your energy partner
OPPD
Omaha Public Power District
444 South 16th Street Mall
Omaha NE 68102-2247
Employment with Equal Opportunity

November 8, 2005
LIC-05-0119

SUBJECT: Fort Calhoun Station Unit No. 1 License Amendment Request (LAR) 05-013, "Criticality Control During Spent Fuel Cask Loading in the Spent Fuel Pool"

"Criticality Control During Spent Fuel Cask Loading in the Spent Fuel Pool"

Figure 2.11

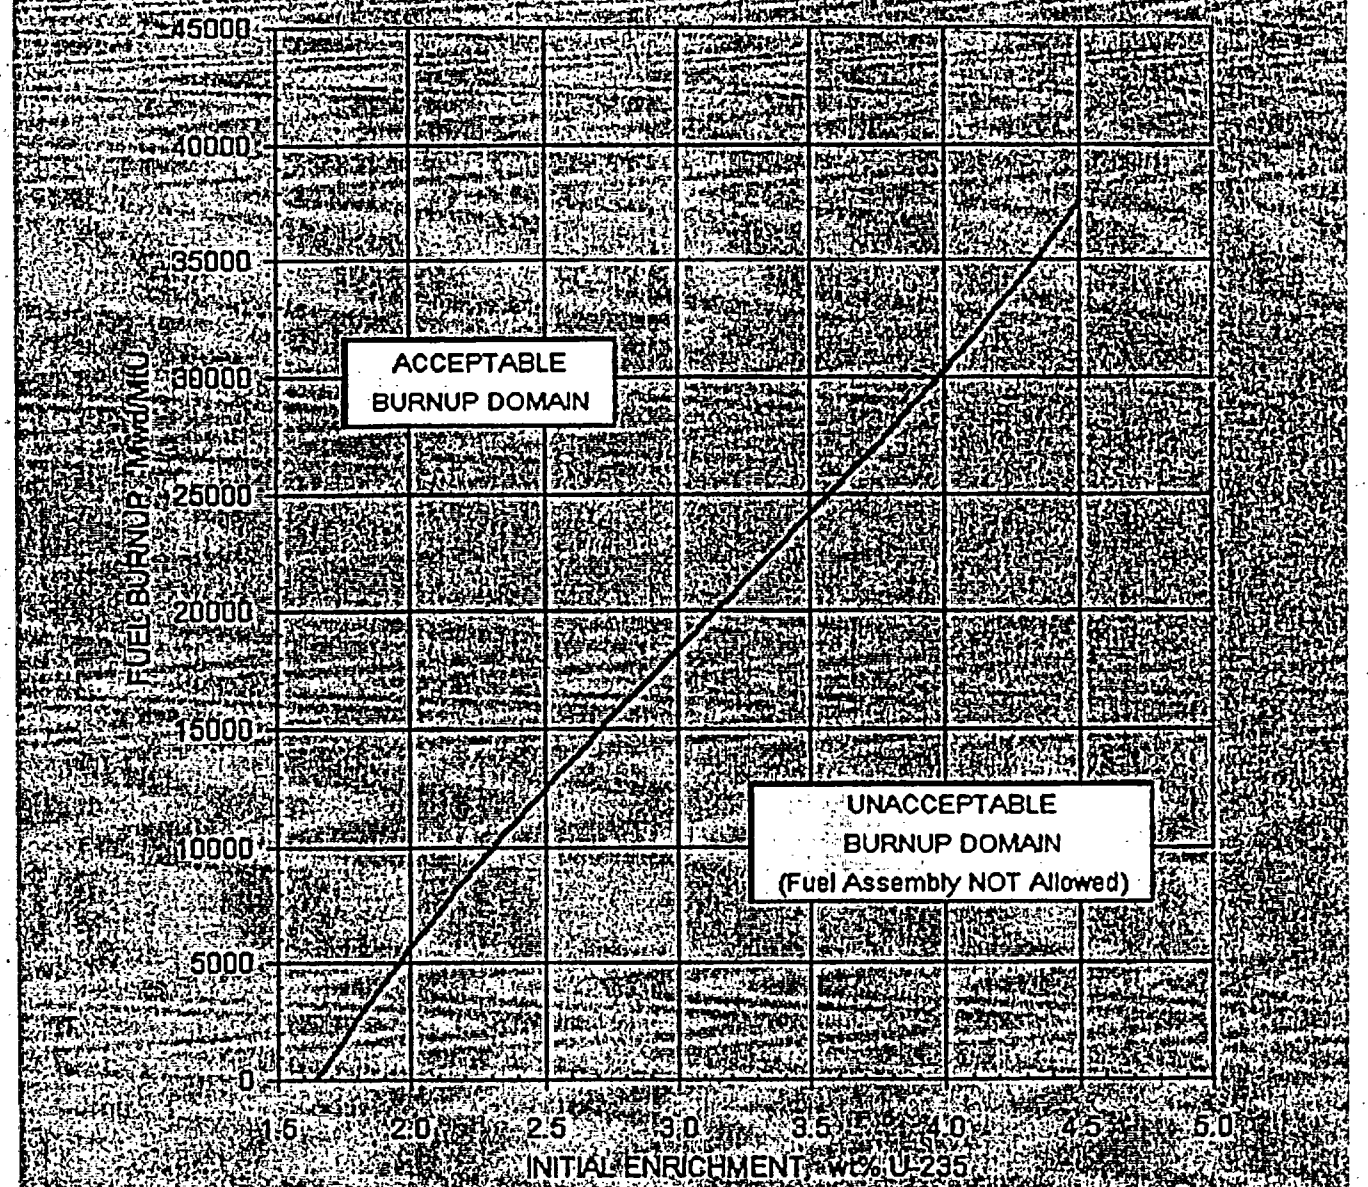
(2) The combination of initial enrichment and burnup of each spent fuel assembly located in a spent fuel storage cask in the spent fuel pool shall be within the acceptable burnup domain of Figure 2-11.

(3) With the requirements of the LCO 2.8.3(6)(2) not met, initiate action to remove the noncomplying fuel assembly from the spent fuel cask immediately.

LIMITING BURNUP CRITERIA
FOR
ACCEPTABLE STORAGE IN
SPENT FUEL CASK

Figure 2-11

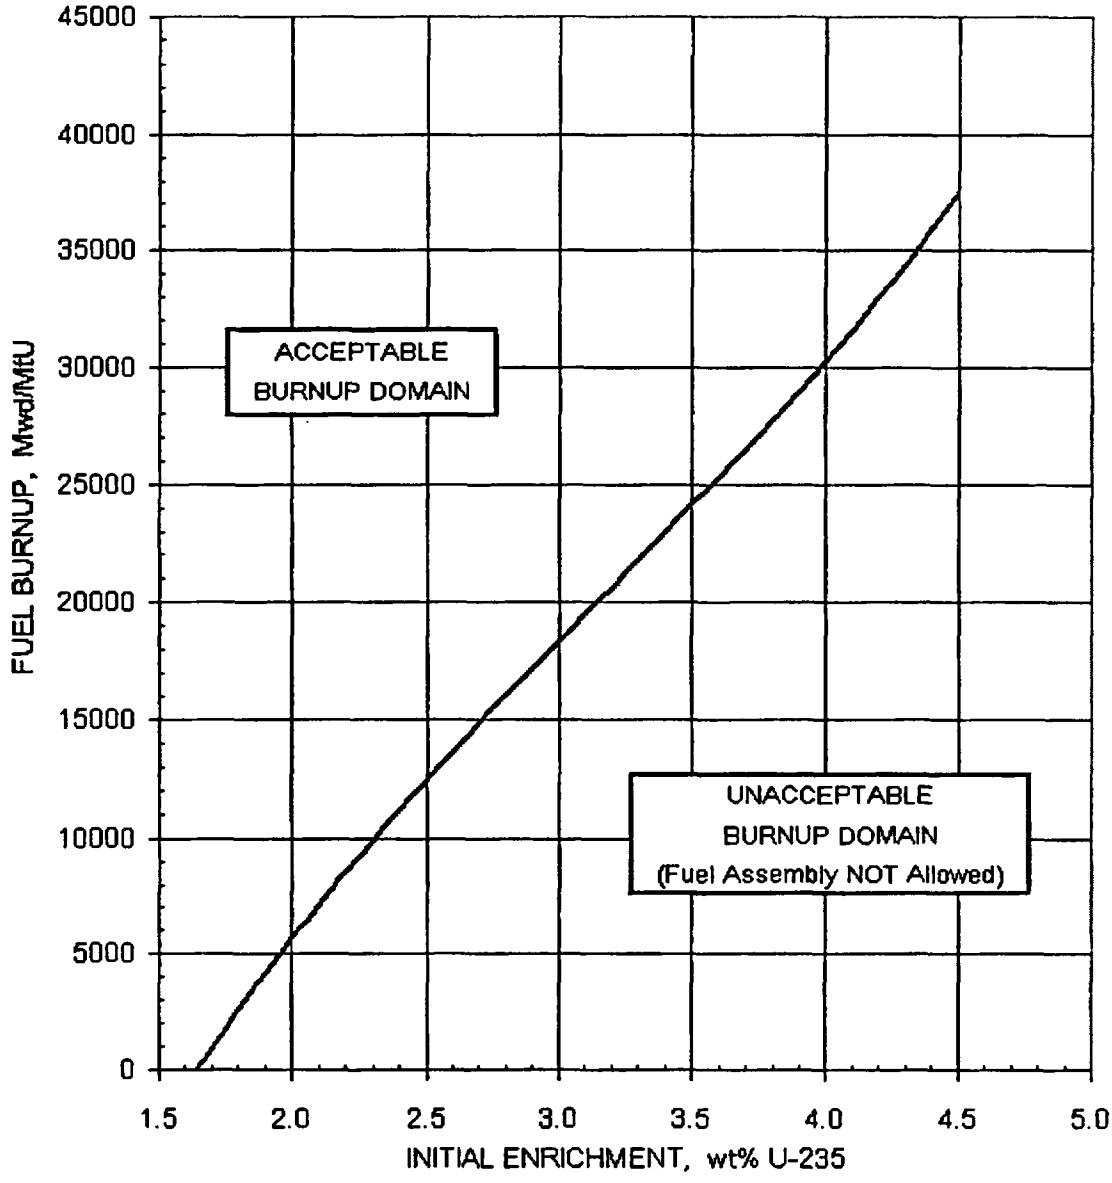
(2) The combination of initial enrichment and burnup of each spent fuel assembly located in a spent fuel storage cask in the spent fuel pool shall be within the acceptable burnup domain of Figure 2-11.

(3) With the requirements of the LCO 2.8.3(6)(2) not met, initiate action to remove the noncomplying fuel assembly from the spent fuel cask immediately.

The spent fuel cask is designed for subcriticality by use of neutron absorbing material. The restrictions on the placement of fuel assemblies within the spent fuel pool, according to Figure 2-11, and the accompanying LCO, ensure that the k_{eff} of the spent fuel pool always remains < 0.95 assuming the pool to be flooded with borated water and < 1.0 assuming the pool is flooded with unborated water, in accordance with 10 CFR 50.68(b)(4).
